CLARK COUNTY, NEVADA BID NO. 603795-15 CIRCUS CIRCUS DRIVE FROM INDUSTRIAL ROAD TO LAS VEGAS BOULEVARD

November 10, 2015

ADDENDUM NO. 3

TYPICAL LIMITS OF INTERSECTION DETAIL
(N.T.S)

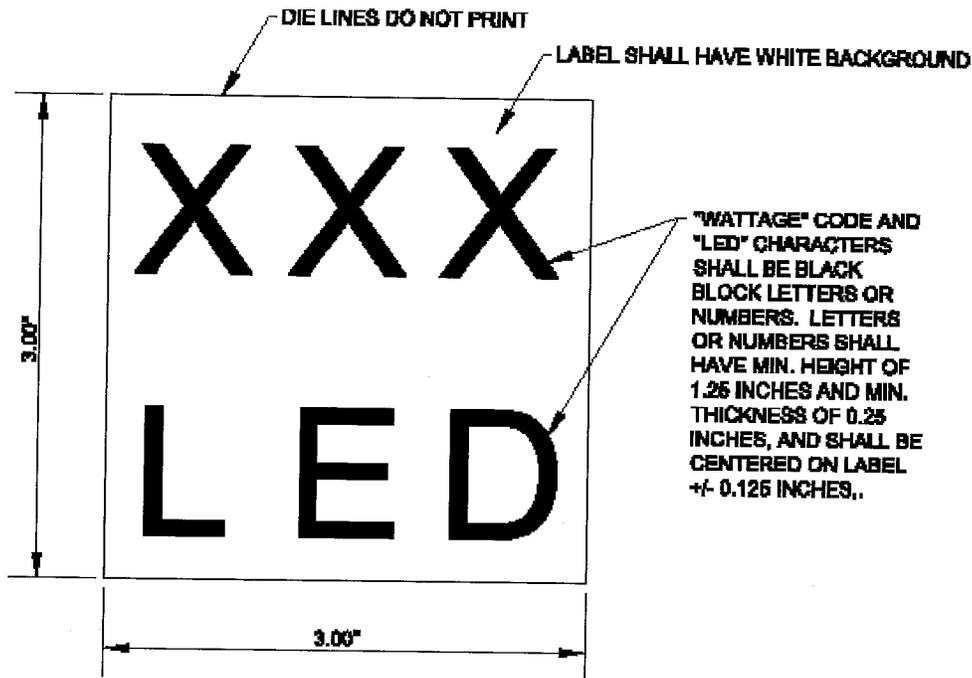
8. Fixtures installed for typical intersection lighting for an intersection shall achieve average maintained illumination as outlined in IESNA RP-8-14, Table 8 (Major/Major, High and E_{avg} / E_{min}) within the limits of the intersection (see Limits of Intersection detail). Lighting luminaire arms are 15 ft in length, with fixtures at the mounting height of 30 or 37 ft. Supplier must provide an illuminance study for both 30-ft and 37-ft luminaire mounting heights, that proves that lighting luminaire standards are met or exceeded per IESNA RP-8-14, with a light loss factor of 0.94.
